Access Compliance Report

Public Rights-of-Way

(Curb Ramps)

Intersection ID: 45512	Main Street: GINHOUSE_LN	Cross Street: HEDGEROW_PARK_RD	Location: SE
ADA ID: 5E0B56133AB3	Ramp Type: PerpDiag	Initial Pass/Fail: Fail	Overall Compliance: No
Severity Score: 17.5			
Codes/Mitigation Info/Possible Solution		Field Measurements/Component Compliance

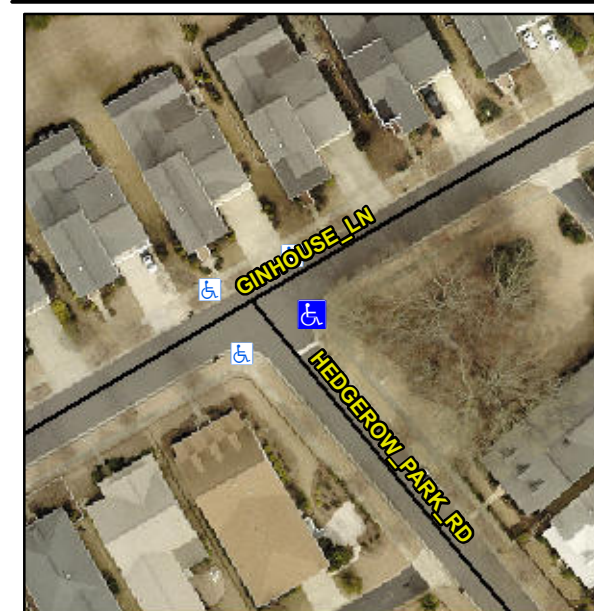
Not Found, R304.5.1

Compliance	Description	Data	Compliance	Description	Data
N/A	Ramp Length (in)	71.0	Yes	Ramp Slope (%)	7.7
No	Ramp Width (in)	33.0	Yes	Ramp XSlope (%)	0.2
N/A	Flare Type LT	N/A	N/A	Flare Type RT	N/A
N/A	Flare Slope LT (%)	N/A	N/A	Flare Slope RT (%)	N/A
N/A	Flare Traversable LT?	N/A	N/A	Flare Traversable RT?	N/A
N/A	Landing Length (in)	N/A	N/A	DWS Provided?	N/A
N/A	Landing Width (in)	N/A	N/A	DWS Contrast?	N/A
N/A	Landing Slope (%)	N/A	N/A	DWS Length (in)	N/A
N/A	Landing X Slope (%)	N/A	N/A	DWS Full Width?	N/A
N/A	Landing Curb? (Y/N)	N/A	N/A	DWS Offset (in)	N/A
N/A	Shared Landing?	N/A			
N/A	Gutter Ponding?	N/A	N/A	Gutter Slope (%)	N/A
N/A	Gutter Lip Ht (in)	N/A	N/A	Gutter X Slope (%)	N/A
N/A	Painted X Walk1?	No	N/A	Painted X Walk2?	No
	X Walk 1 Direction	To NW		X Walk 2 Direction	To SW
N/A	X Walk 1 Width (in)	N/A	N/A	X Walk 2 Width (in)	N/A
	X Walk 1 Slope (%)	1.5		X Walk 2 Slope (%)	1.3
	X Walk 1 X Slope (%)	3.3		X Walk 2 X Slope (%)	4.5

Remove & Replace Curb Ramp With Two New Directional Ramps or Equivalent.
